From: Andrea Tepley <ATepley@mti.org>
Sent: Wednesday, July 9, 2025 12:56 PM
To: allisonstocker@Coloradosprings.gov
Subject: Considerations for proposed building site at Springcrest Rd.

Re: Project: Briargate/Voyager Zone Change and Land Use Plan
1625 Springcrest Road, Colorado Springs, CO 80920
LUPL-25-0010
ZONE-25-0023

To Proposal: Zone-25-0023/LUPL-25-0010

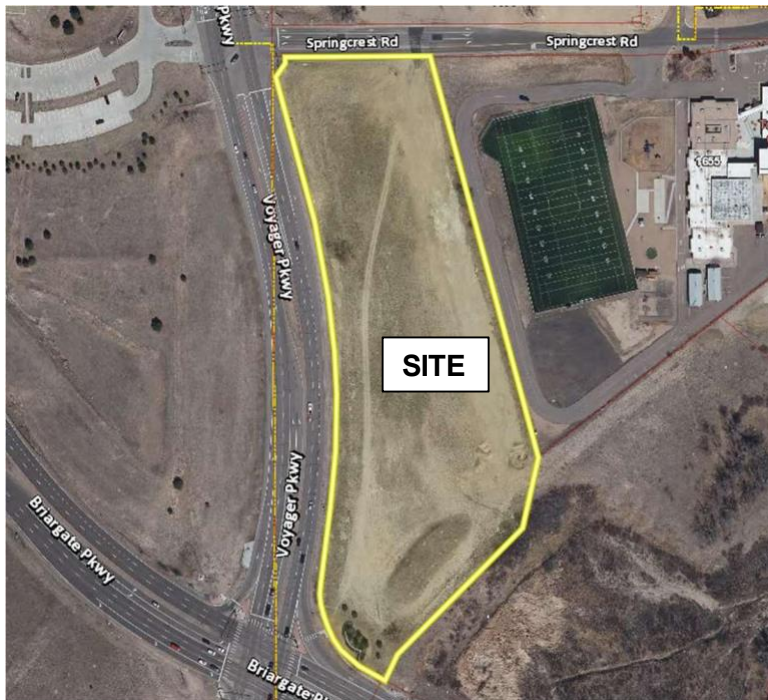
This zone change supports the adaptive reuse of vacant underutilized site in this area.

“Consistent with the surrounding zoning” only if you ignore the rural nature of the long-established and adjacent neighborhood directly north of this proposal.

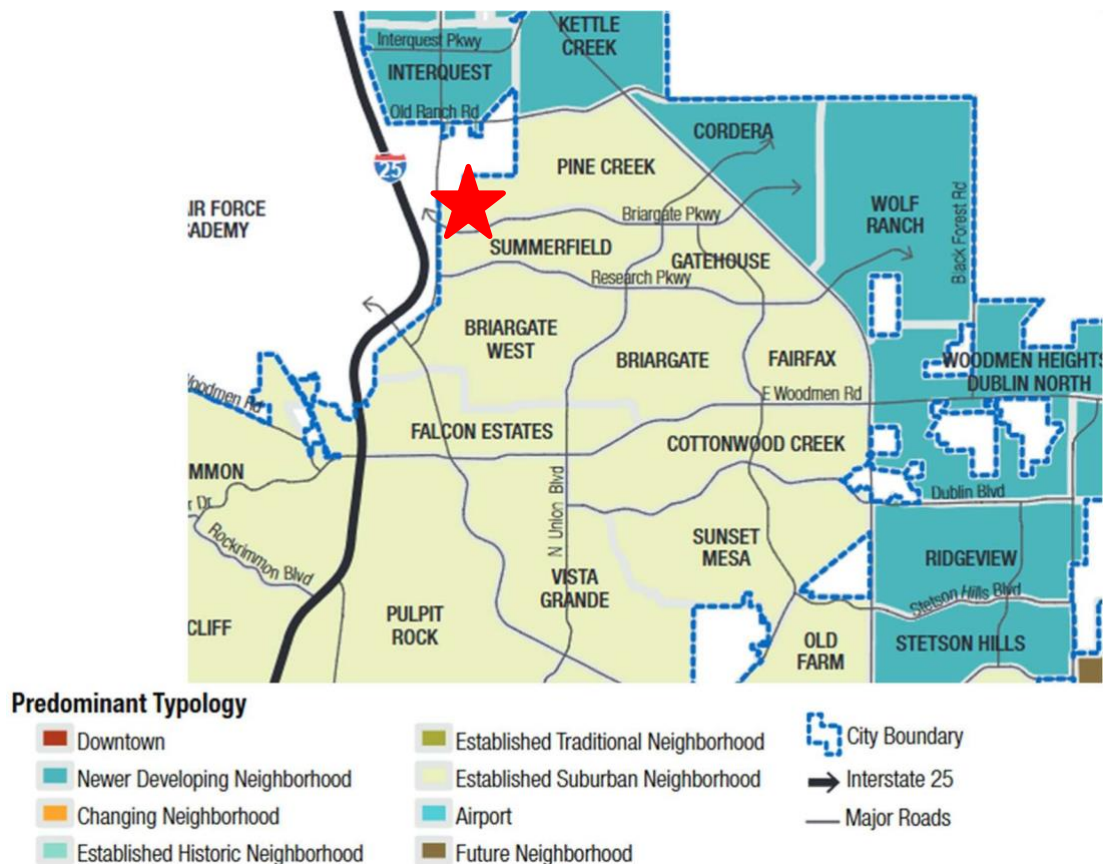
Zoning surrounding the site is Agriculture to the East and North. BP (Business Park) to the southeast and MX-M (Mixed Use Medium) to the South. The City of Colorado Springs boundary line lies west of the property with a small segment of land zoned BP between the County boundary line and the subject parcel. **This map/statement conveniently omits the large rural residential community to the North, which is wholly incompatible with high-density multi-family housing.**

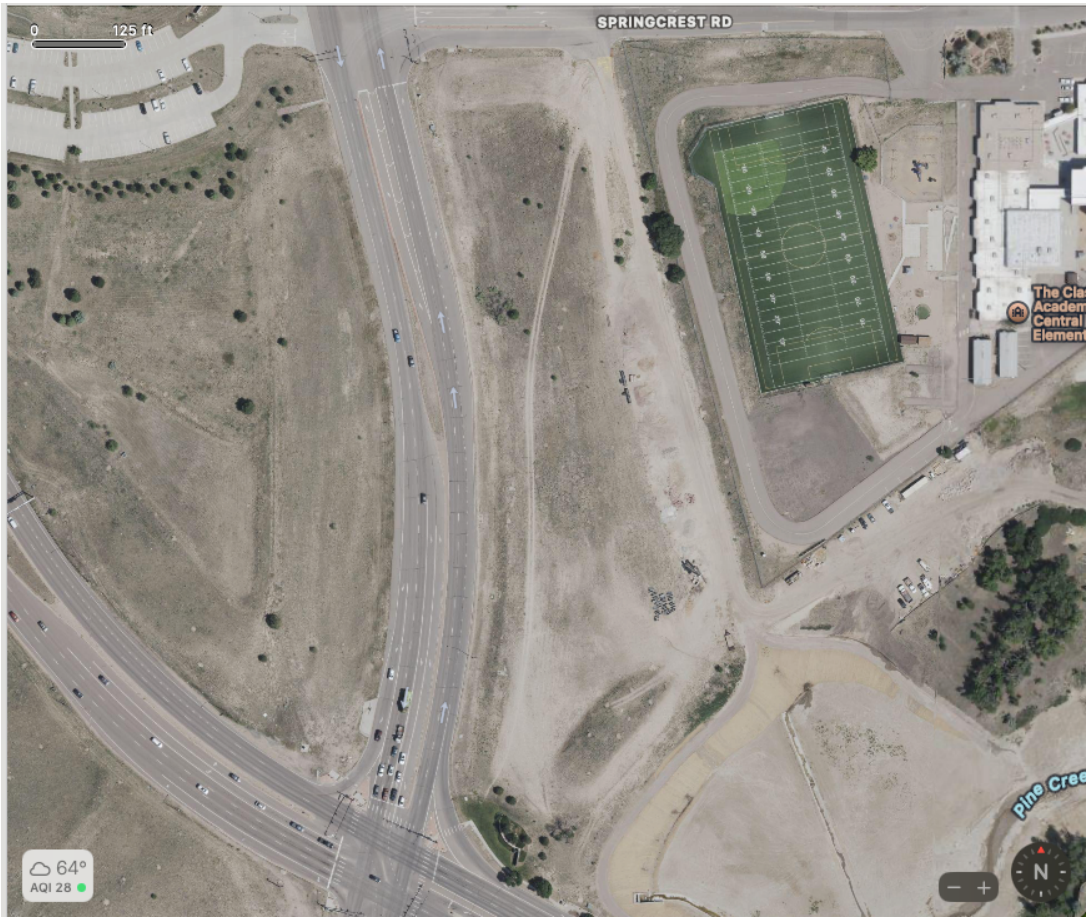
-A northbound Voyager merging lane off of Research/voyager highlight the challenges of getting onto Voyager. This is an actual merging lane with no street at the end of the end of the merge. So the far right lane is only concerned about getting onto Voyager and the Voyager North lane's focus is on zipper merging with this lane) While our Springcrest/Voyager lane isn't merging but a right turn, those wanting to continue north to Voyager will come to a stop prior to turning on to Springcrest and impede the flow of traffic for those in that right lane. Even if there was a yield sign from Briargate W to voyager, the short right turn lane off of Briarcrest could easily spill into Westbound Briargate.

Describing the traffic concerns in words is a challenge with all the directions/streets I'm referencing. If you look at a google map, it clearly shows the short distance between Briargate and Springcrest. The distance to merge in/out of the right lane to get from Voyager to Springcrest East or Briargate W to Voyager north without crossing a solid is approximately 625 feet. The proposal requests adding another point of entry to that right lane approximately midway between Springcrest and Briargate. That makes a bad situation significantly worse. See the attached photo and distance key in the upper right corner for reference.

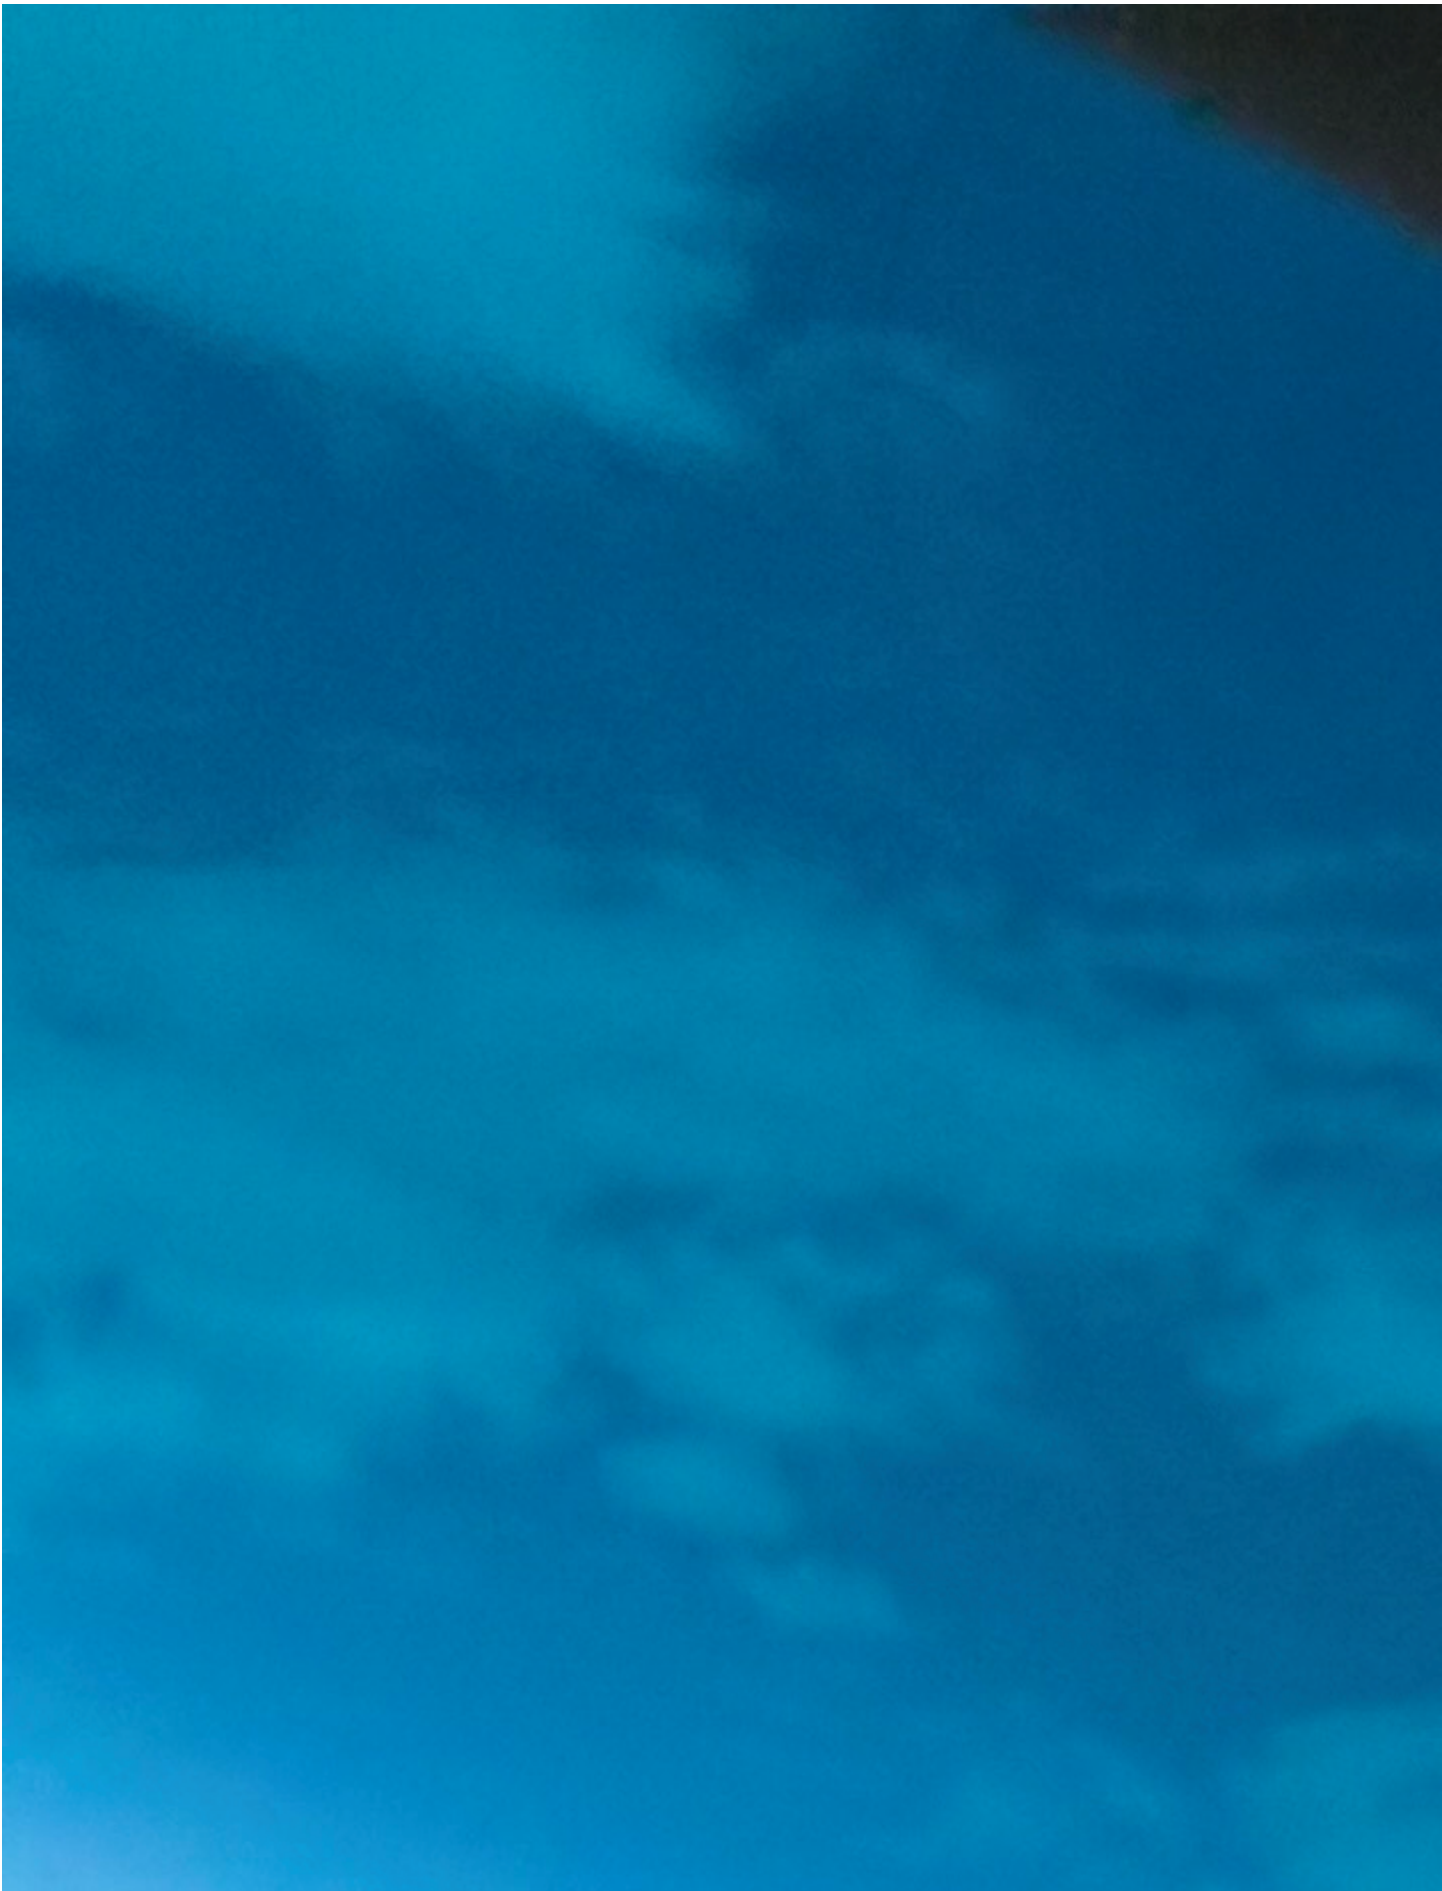
I am also attaching photos of the traffic at Friday pick up time for the school (it releases at 12:15 p.m. on Fridays). I was in my vehicle on Voyager Parkway and the pictures are of the back up of traffic on Springcrest/Voyager

and the carpool line at TCA Central.
